# CITY OF ALBUQUERQUE

**Re: A.I.S. Retail  
Grading and Drainage Plan (H13D106)  
Engineer's Stamp Date, 7-18-15 (Sheets C1, C2, C3 & C4)**

**Re: A.I.S. Retail  
Grading and Drainage Plan (H13D106)  
Engineer's Stamp Date, 7-9-15, 7-7-15 & 6-25-15 (Sheet C1, C2 & C3)**

**Re: AIS Retail; 12 St & Indian School/Menaul; Grading and Drainage Plan (H13D106)**

TYPICAL CROSS SECTION FOR FIRST FLUSH PONDING IN PARKING LOT MEDIANS

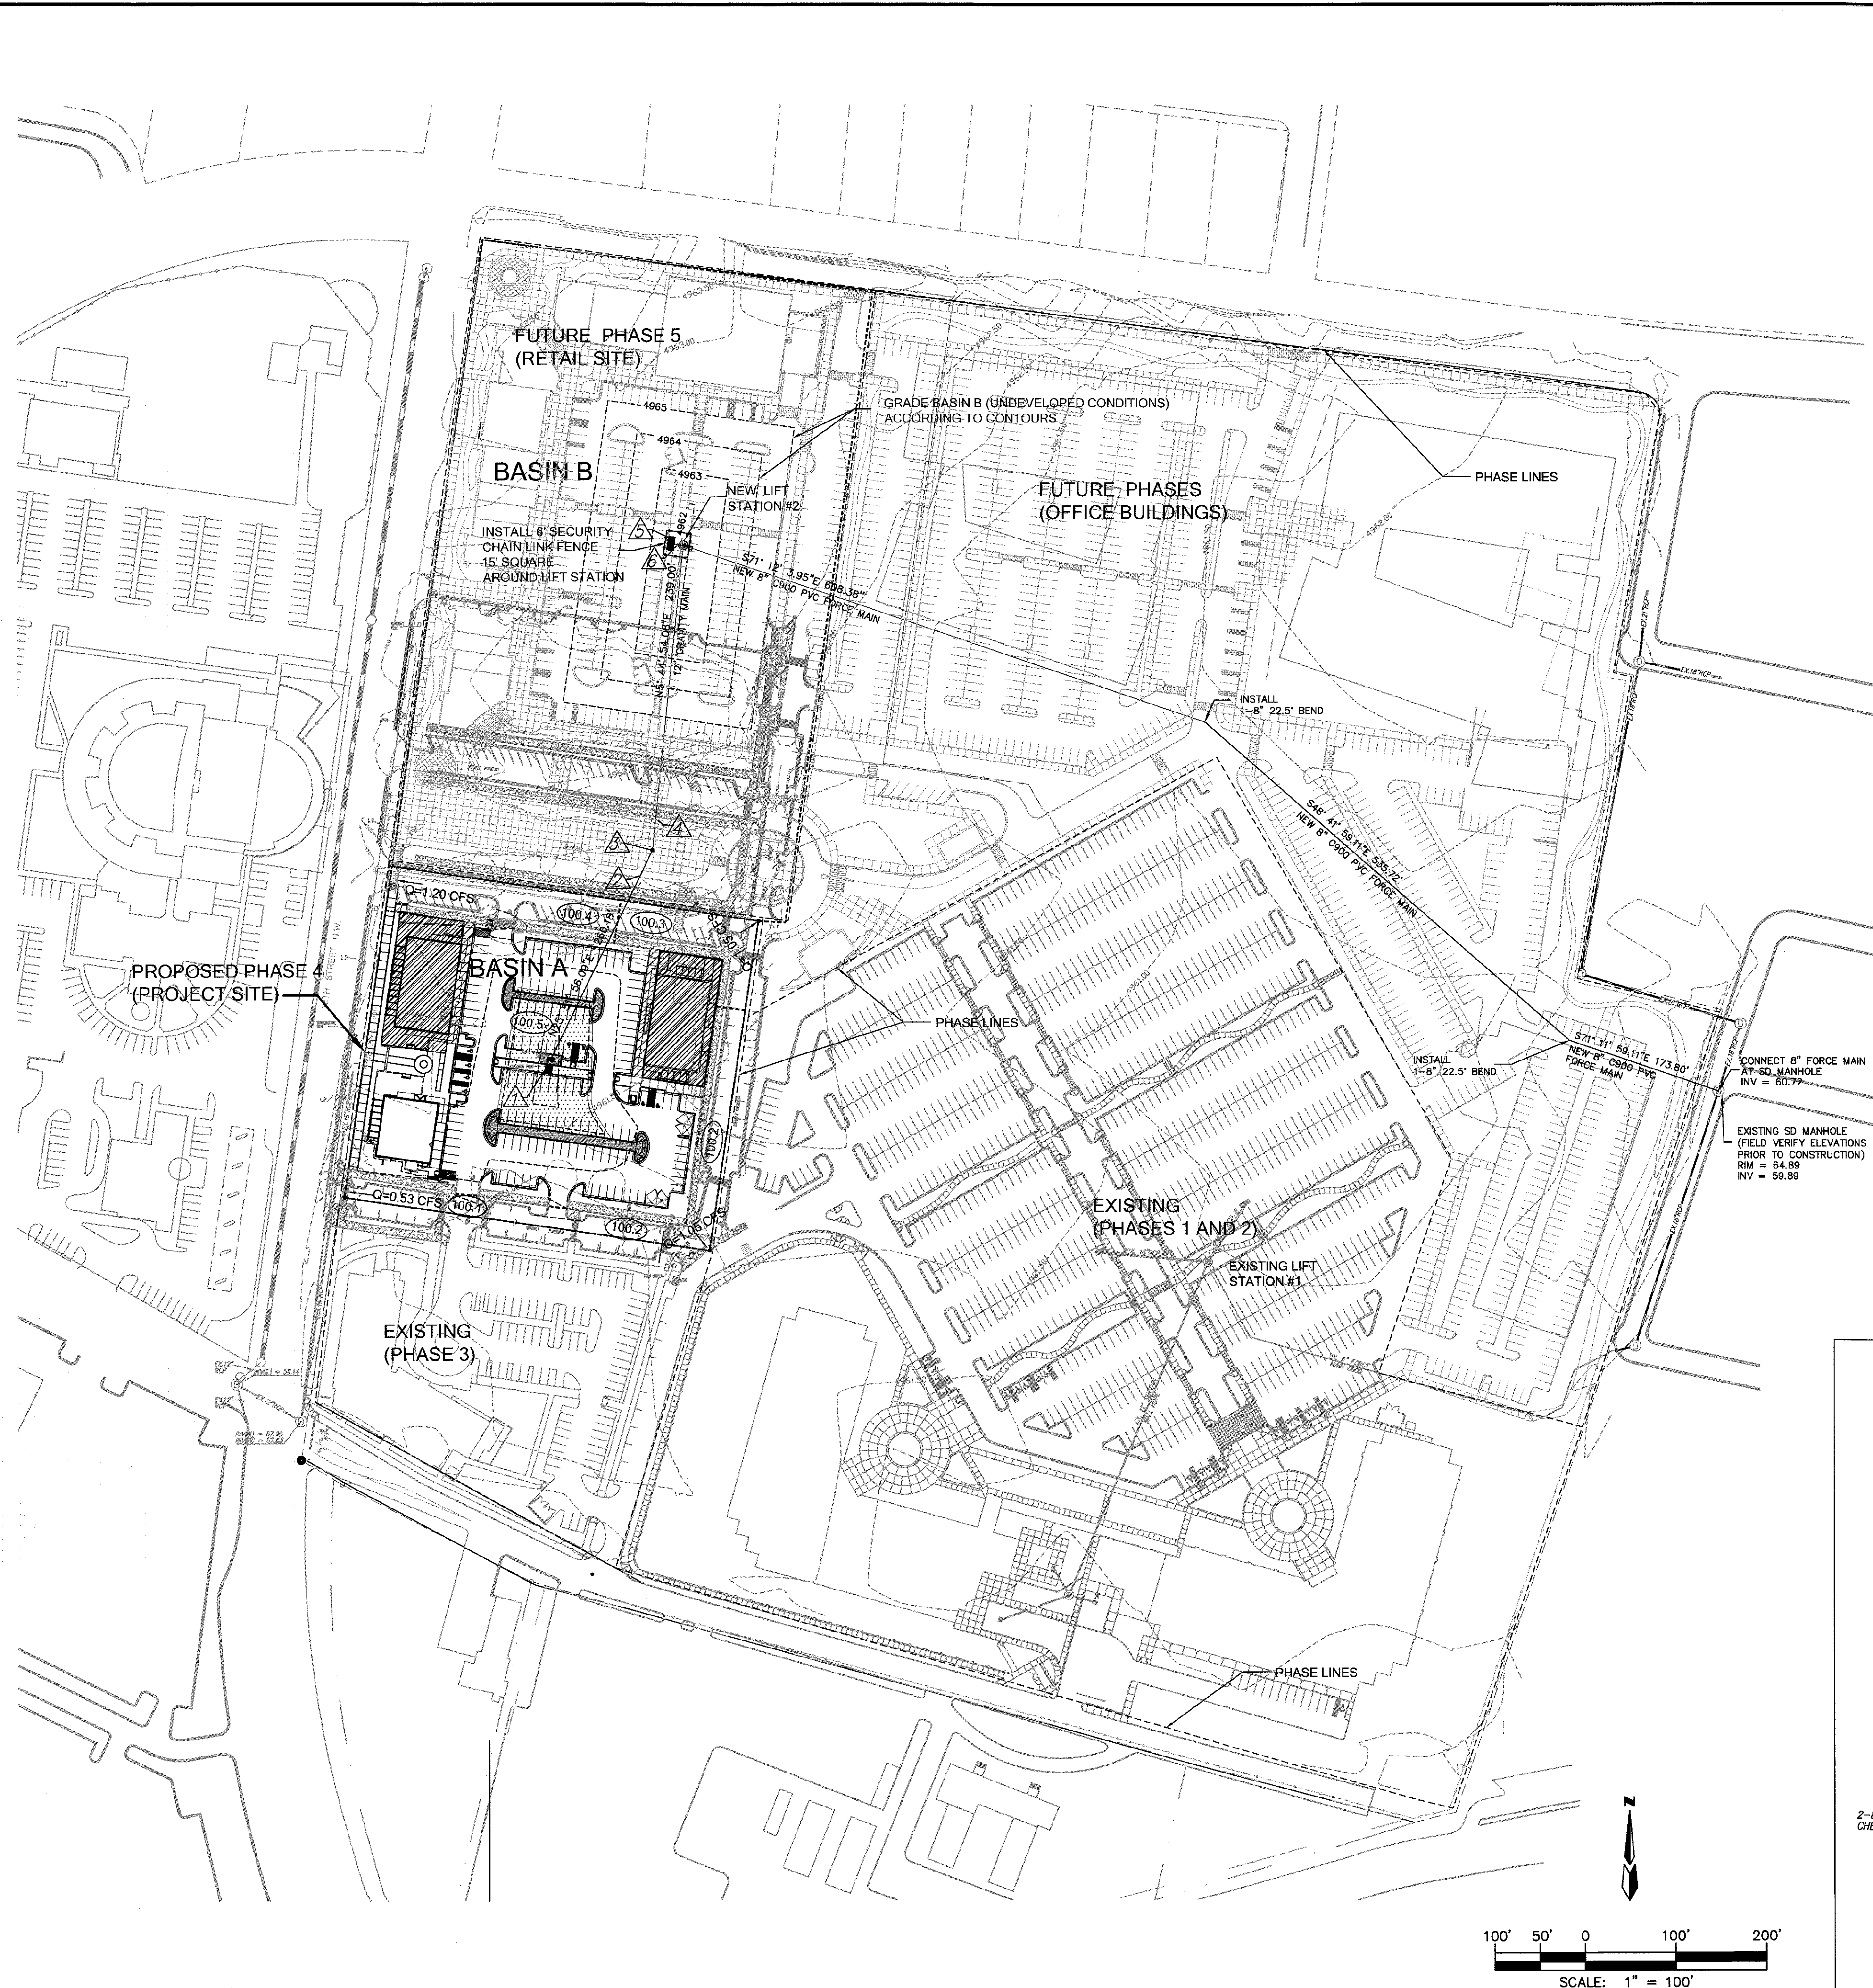
- Please provide the bottom of the pond elevations where first flush ponding is proposed. Some areas along the parking lots may have more than 18" of vertical drop. Therefore, handrail will be required. A retaining wall should be used for these areas.

- **"Please provide the bottom of the pond elevations where the first flush ponding is proposed..."** Please see pond elevations on Sheet C1.
- **"Is the grate elevation for the double "D" inlet at the bottom of the pond? How does the sidewalk culvert tie into the inlet?"** Please see changes on Sheet C1. The inlet has been relocated to the middle of the first flush pond A2 and will be in a sump condition. The

top of the grate is at elevation 62.00'. The sidewalk culvert will discharge into pond A2 (outfall invert of the sidewalk culvert is 62.20'). The gravel lined bed shown on the "Typical Cross Section for First Flush Ponding in Parking Lot Medians" will help prevent erosion.

Sheet: C2 of 4

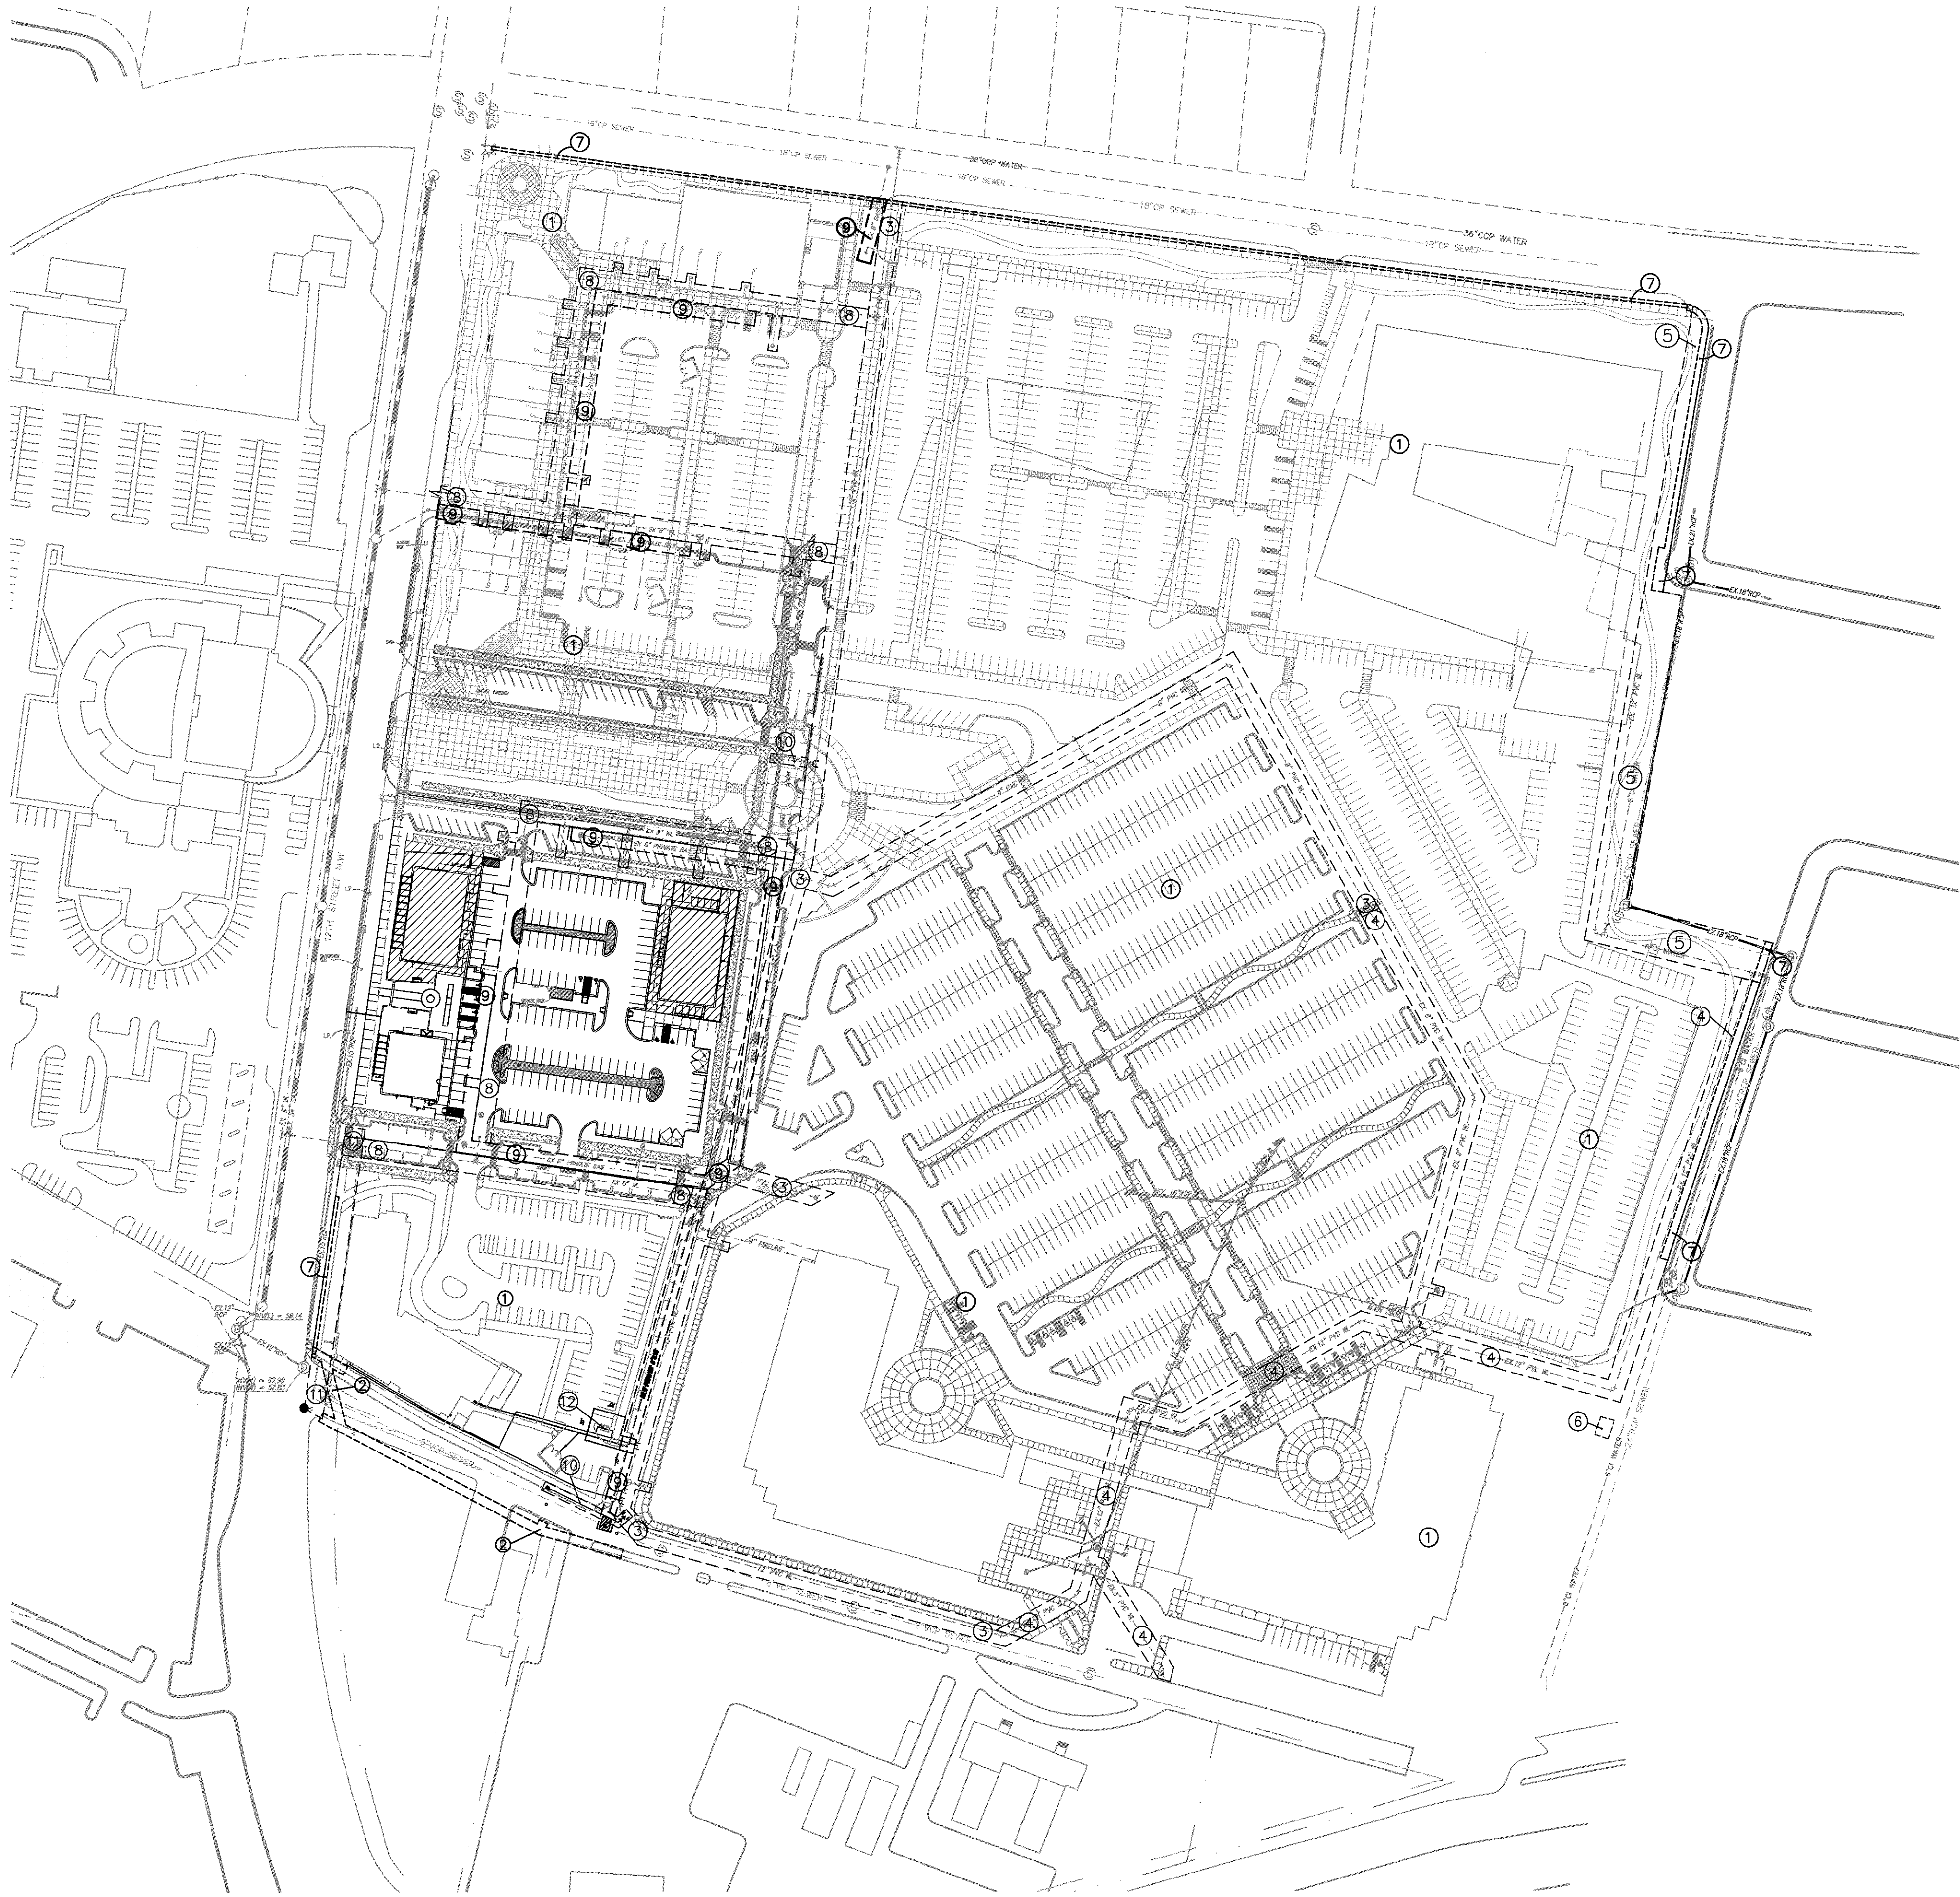
- Please correct the force main line size on sheet C3 of 3.
- Show existing contours. Provide contour elevations on sheet C2 of 3.
- Who will be maintaining the storm drain system?

- **"Please correct the force main line size on Sheet C3"** Please see changes on Sheet C3.
- **"Show existing contours. Provides contour elevations on sheet C2"** Please see changes on Sheet C2. Please note that the site has been regraded since the topography of these existing contours was complete. The existing spot elevations show the grades after the site was regraded.
